PRE-PRODUCTION FEEDBACK

Date: 23-12-2020
Revision: 1.0
Author: Tony Little
Product: Electric Skateboard
Company: Globe Brand

2.1.1 BATTERY CHARGER REGULATOR SOLDERING

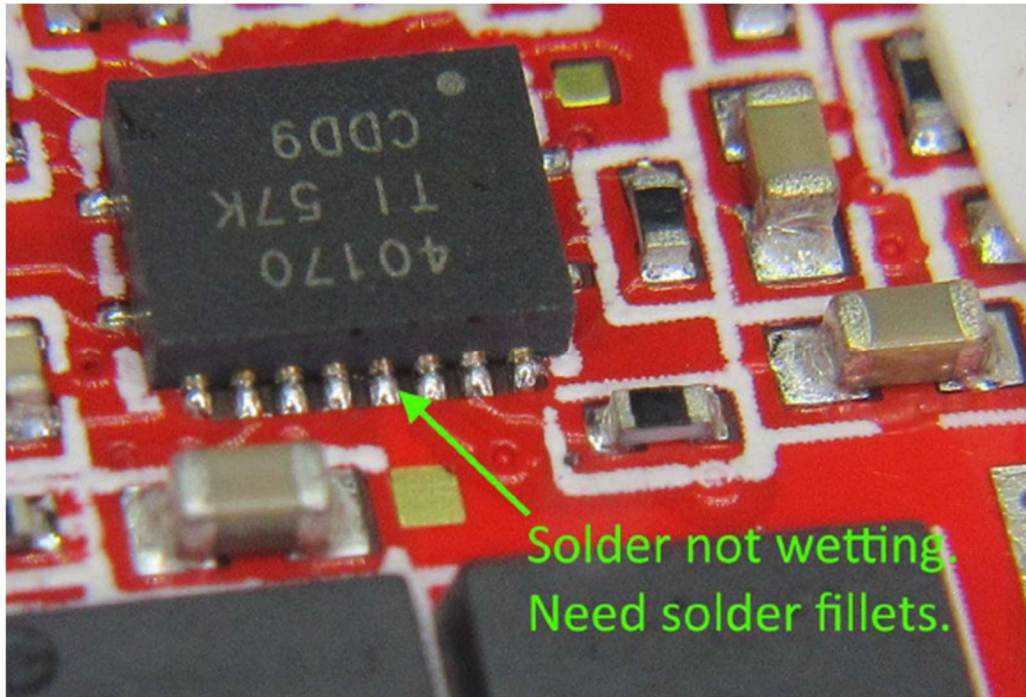
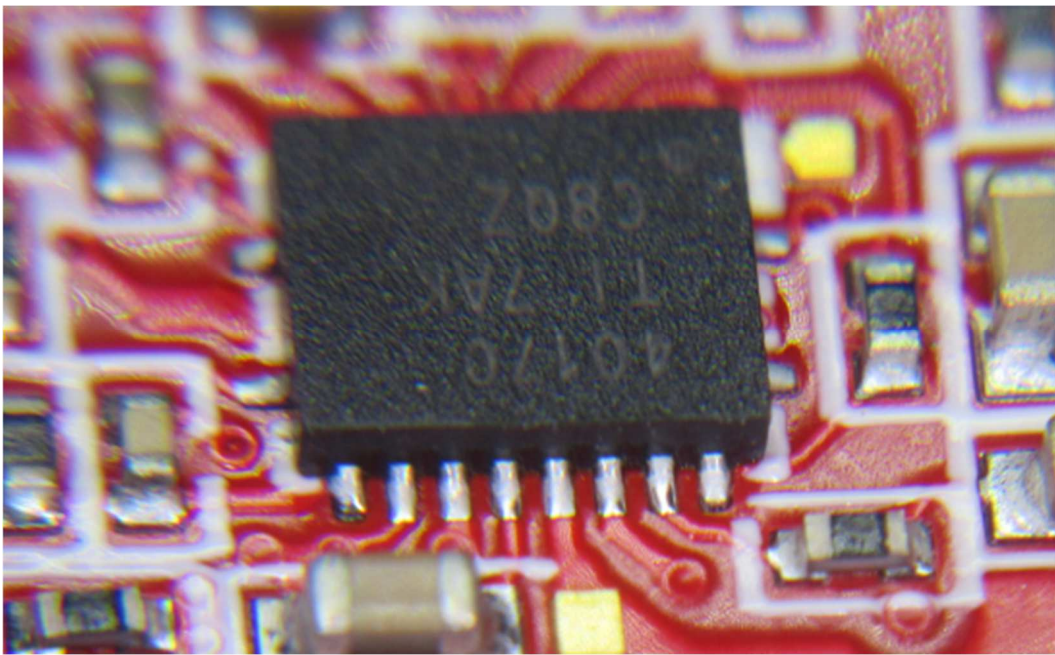
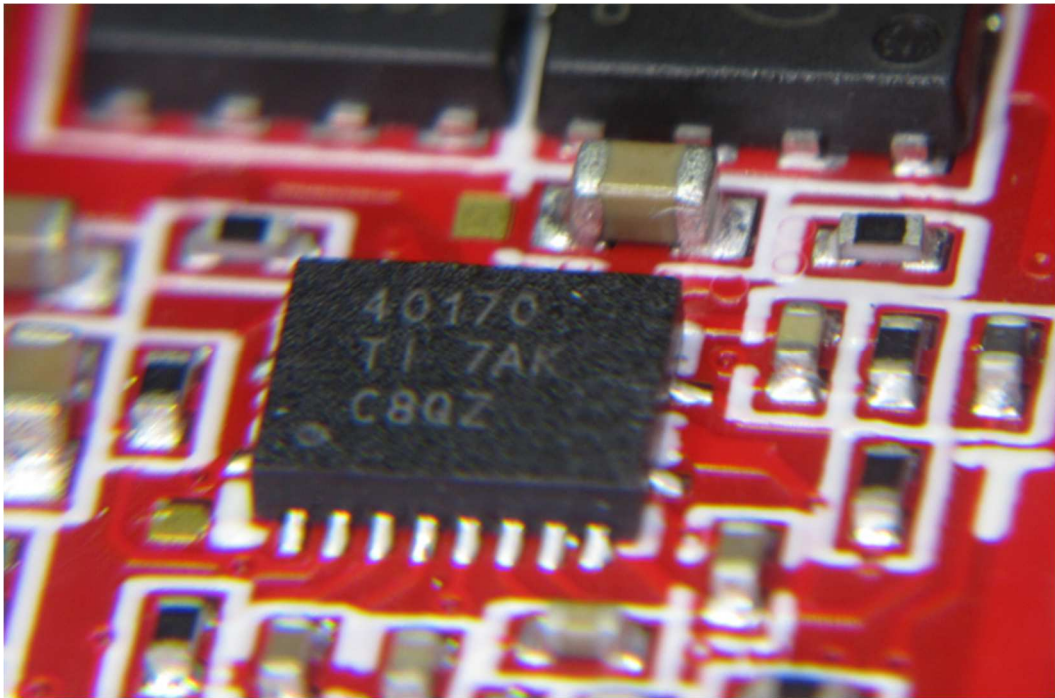
Previous concern has been the poor solder wetting on IC2.

Union applied addition flux prior to reflow, which has resulted in a significant improvement.

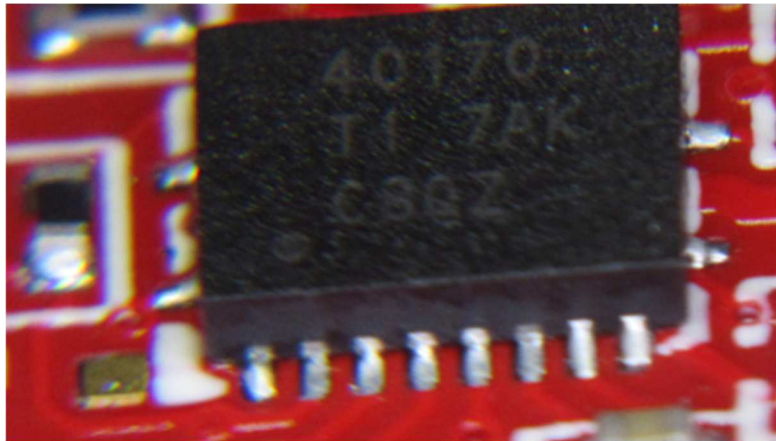
The worst example from the set of 5 is shown below. Possible indication of production variation.

2.1.2 USB CONNECTOR SOLDERING

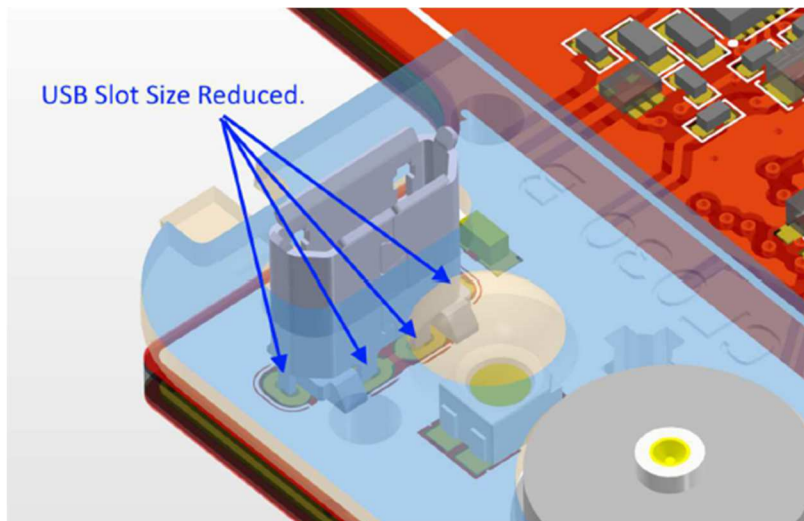
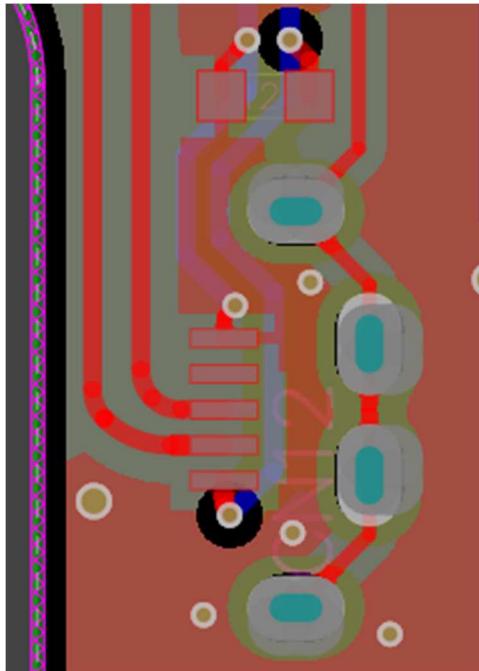
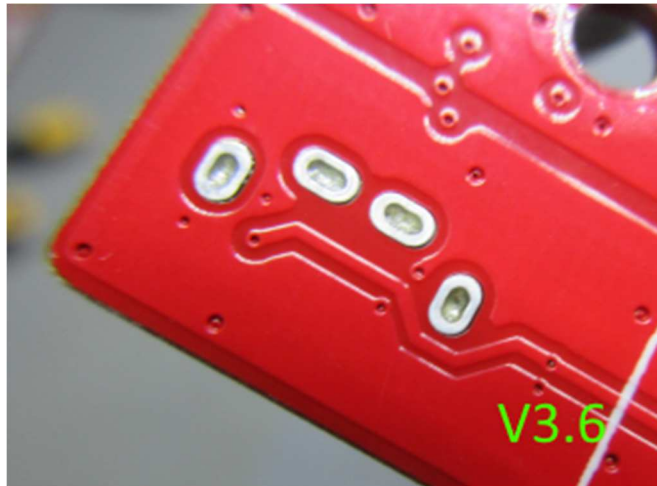
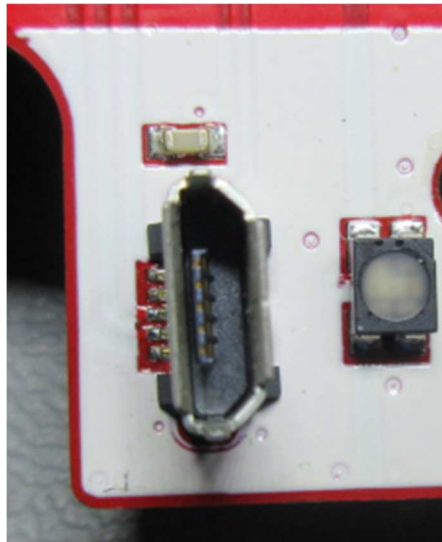
The same USB connector footprint update on the remote was applied to the MC. The changes were to improvement alignment and to increase solder fill.

The paste geometry update as shown below. Paste increased beyond mask perimeter for chassis pins.

The improvement in solder fill is quite noticeable. Below shows V3.5 in comparison to V3.6. This may both improve USB connector retention/strength as well as make Jesse happy.

All USB connectors are well aligned.

2.1.3 INDUCTOR L3 SOLDER MASK CHANGE

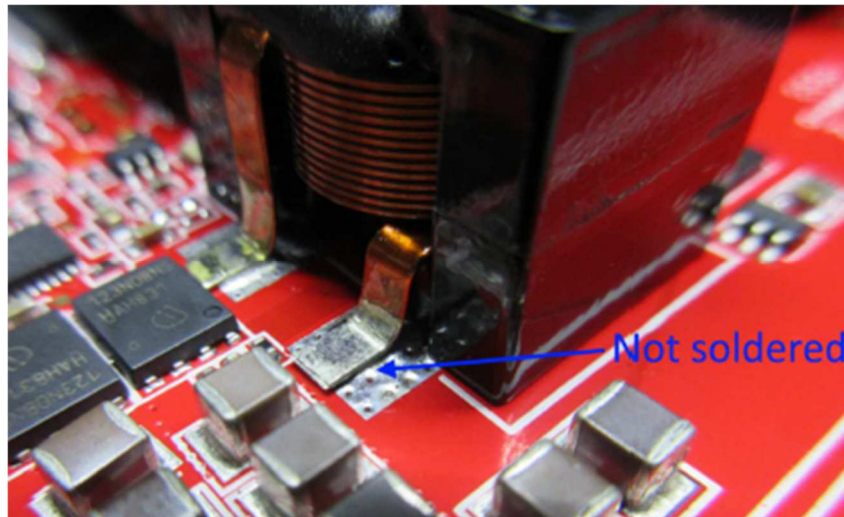
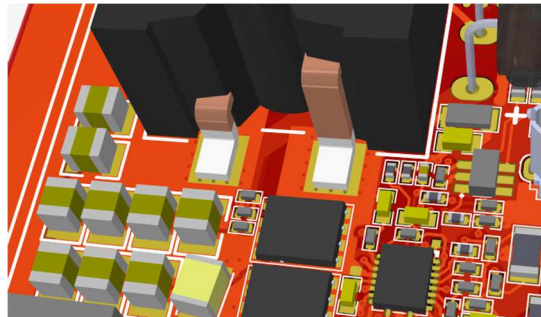
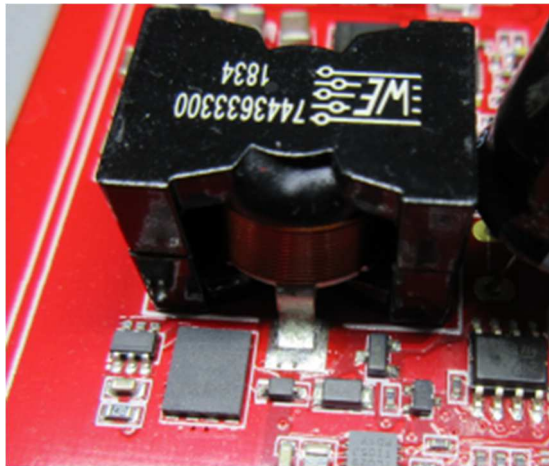
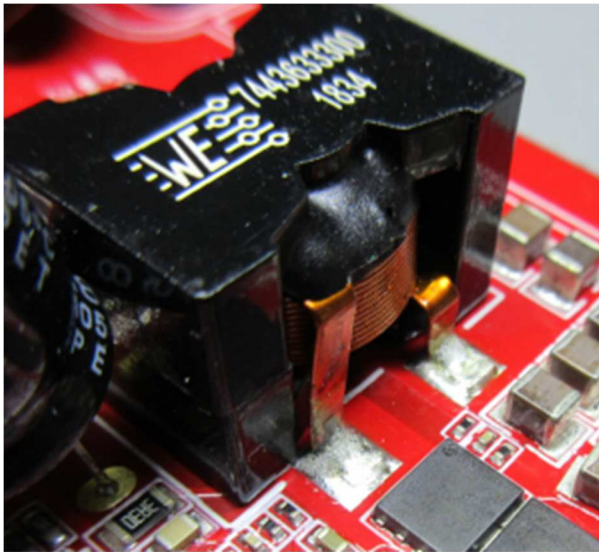
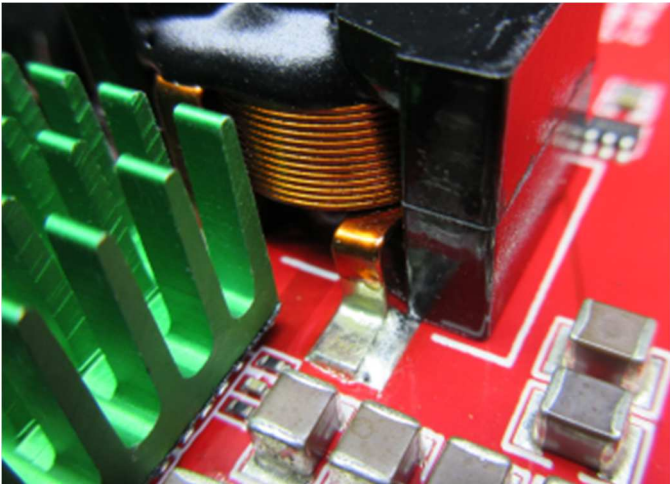
Several prior production faults were due to soldering issues with the large battery charger inductor. Both joint and inductor mis-alignment issues. Footprint used was as specified by the manufacturer.

The PCB footprint design was updated with a reduced mask area, while maintaining paste beyond mask perimeter.

Significant improvement in solder fillet/volume observed. Change most evident.

Worst case example below. Mis-alignment considered minor.

2.2.1 FFFFE022

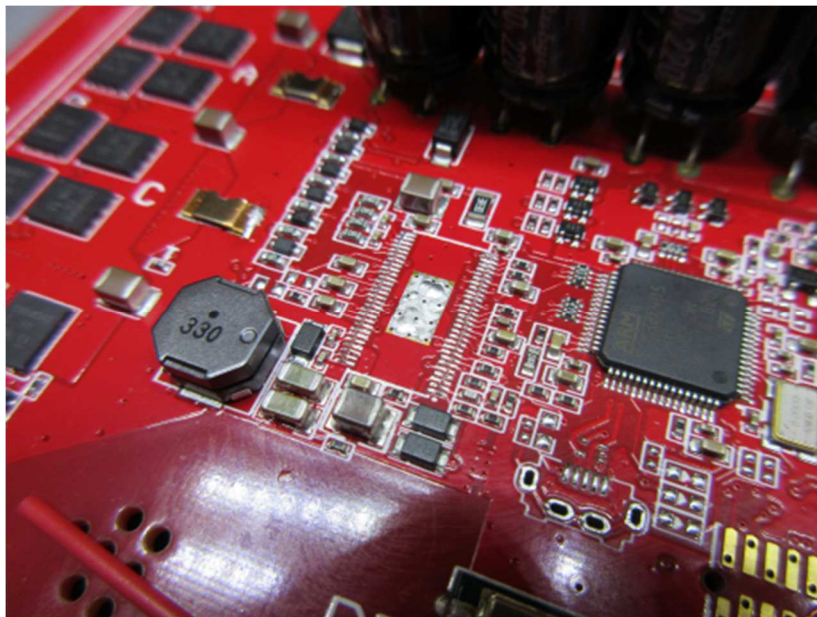
Right VESC has a motor start issue. Jolts from certain phase angles.

Resoldered many joints, no impact.

Re-flashed firmware.

Checked bridge commutation signals. Clean.

Checked bridge gate signals. Clean.

Drives motor under load.

Engaging brake causes jolt and no brake for a period.

Replaced bridge driver, no change.

Log file captured right VESC over current fault.

Fault not yet determined.

3.2 WIRE SOLDERING

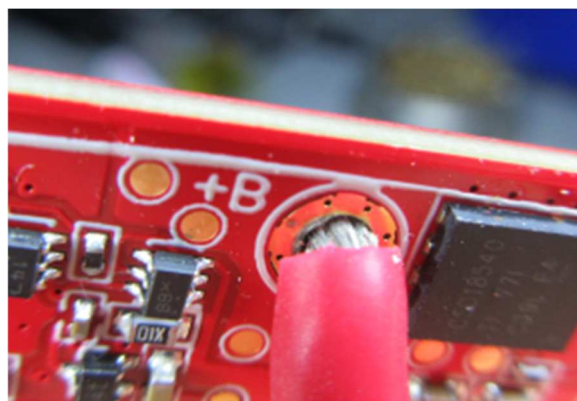
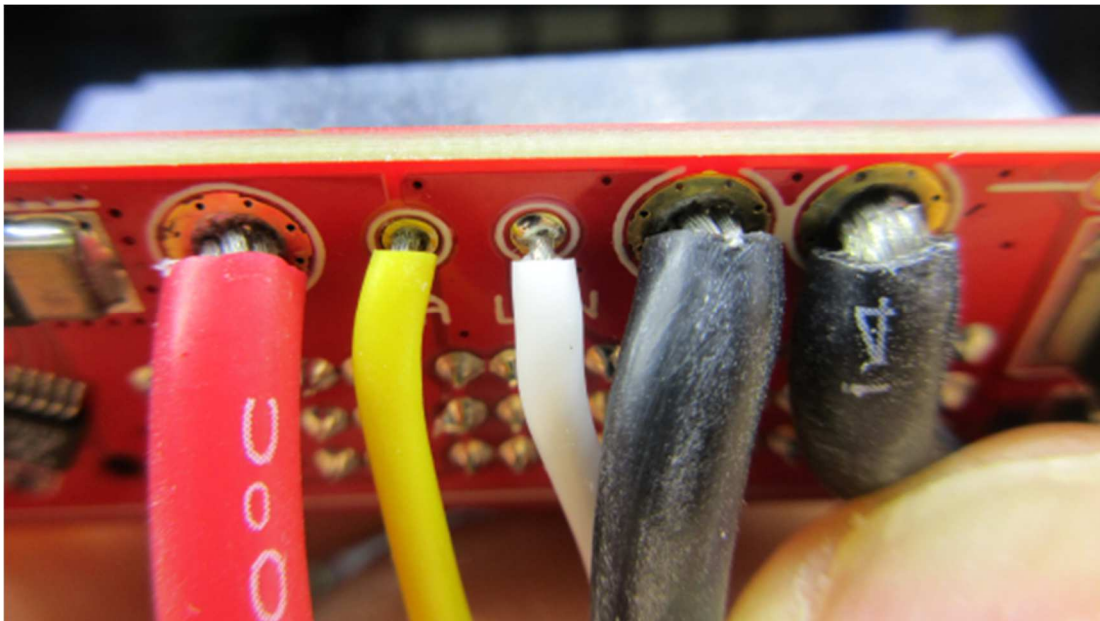
The wire soldering has historically not been at the desired level, however has never been a functional issue. The wiring holes were increased slightly at Unions request to improve the through hole fill and filleting on the opposite solder side. The land area was also increased slightly.

The through hole is getting sufficient fill for the functional requirement. Operator soldering speed is likely pushed too fast. Hot air pre-heating would also be preferable.

Although still not at the desired level, there is no historical functional issue to pursue further changes.

3.2.1 BBBB009A

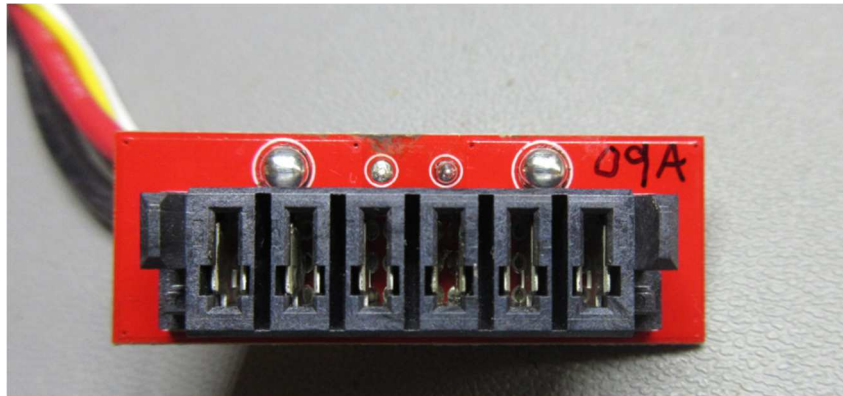
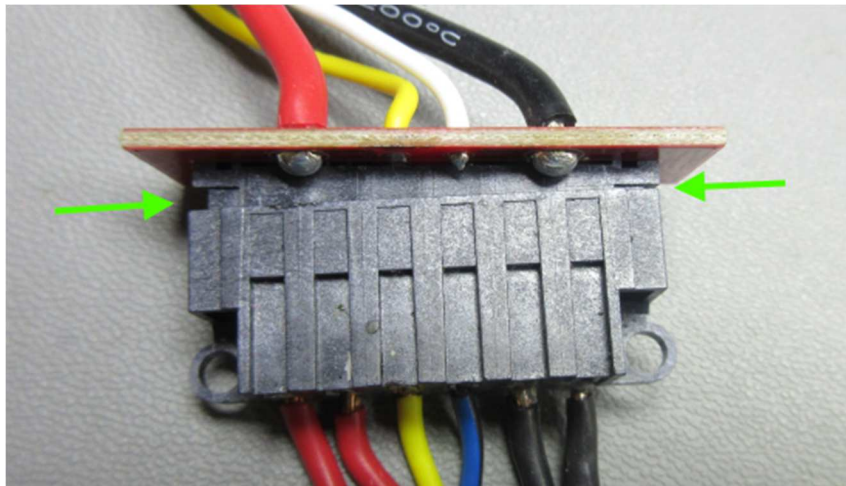
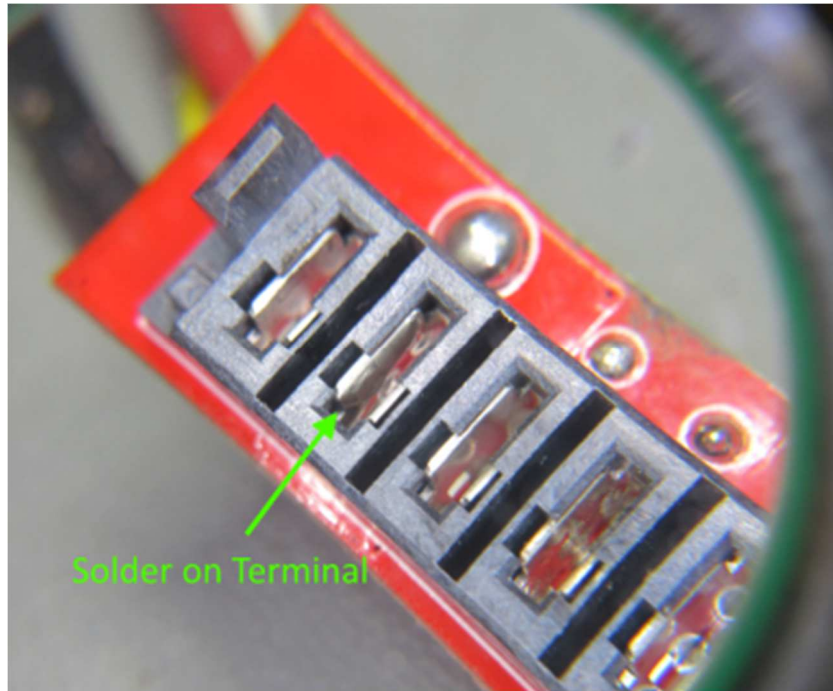
Inspection found the front connector to have solder wicked into terminal contact. This causes a fitment issue for full connector mating.

4.2 OLED PROTECTION

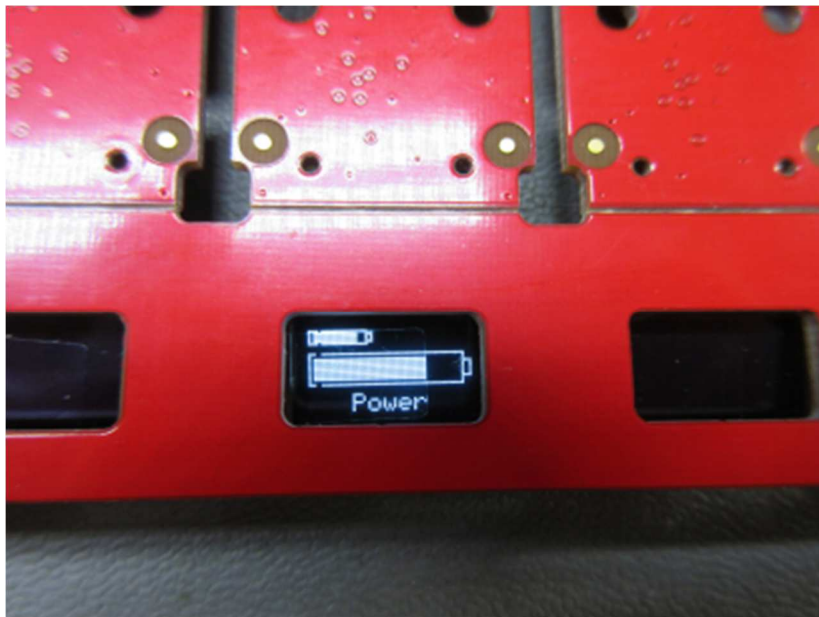
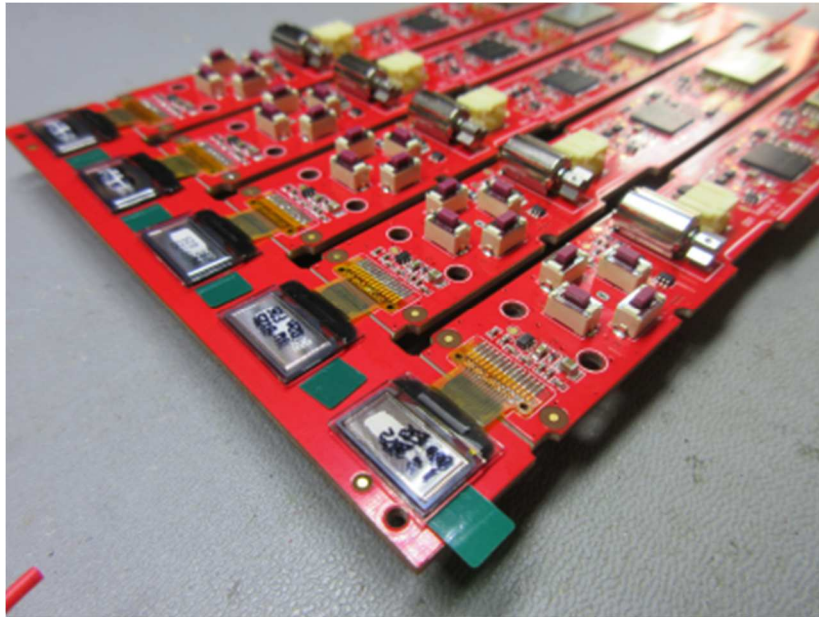
OLEDs have the desired additional support for handling and shipment.

4.3 OLED ALIGNMENT HOLES

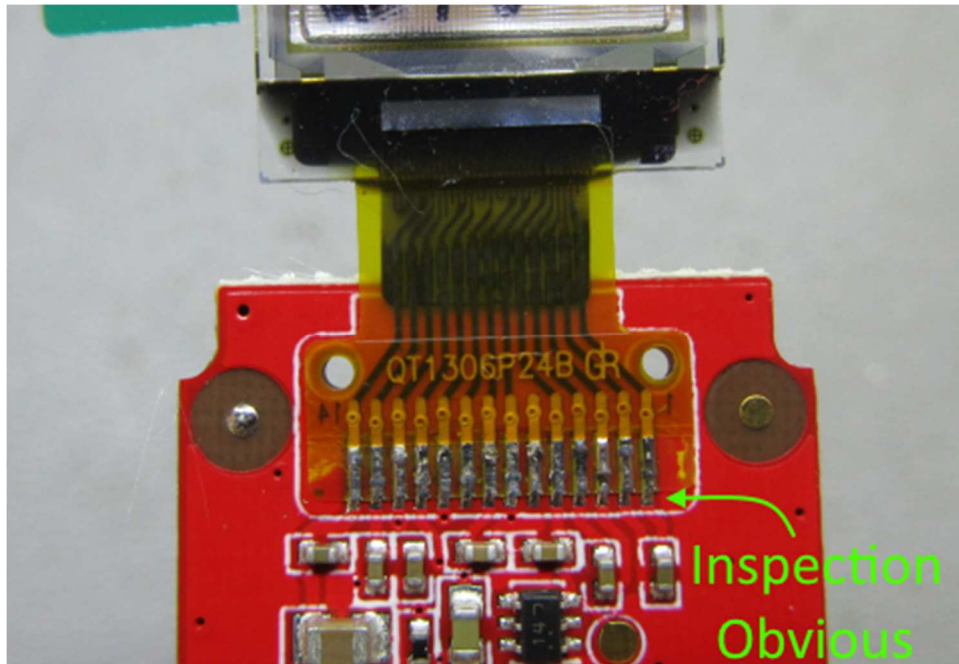
OLED alignment holes moved 0.25mm and increased to 1.1mm diameter. This is to improve tab soldering inspection and jig alignment fitment.

Samples would have been prepared without a jig for alignment, which is noticeable. Given due consideration, change gives the desired obvious soldering edge inspection.

4.4 ANTENNA PROTECTION

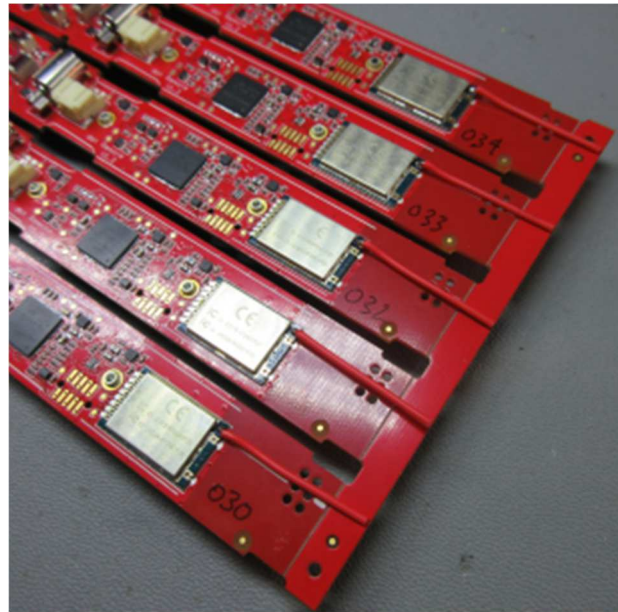
The extended panel breakoff is just enough to avoid a lot of antenna displacement while handling and being packaged.

4.5 DE-PANELED

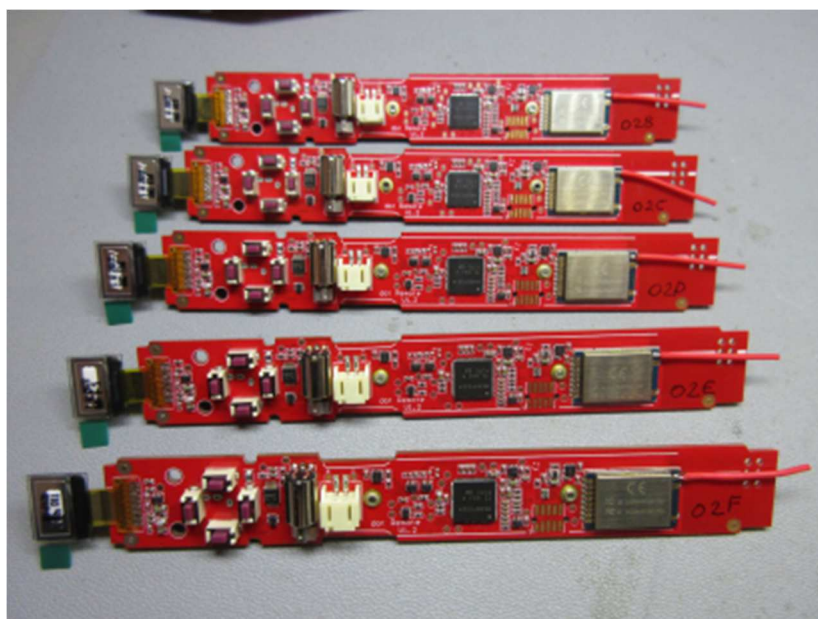
De-paneling easy. The OLED end should be broken off without touching the OLED.
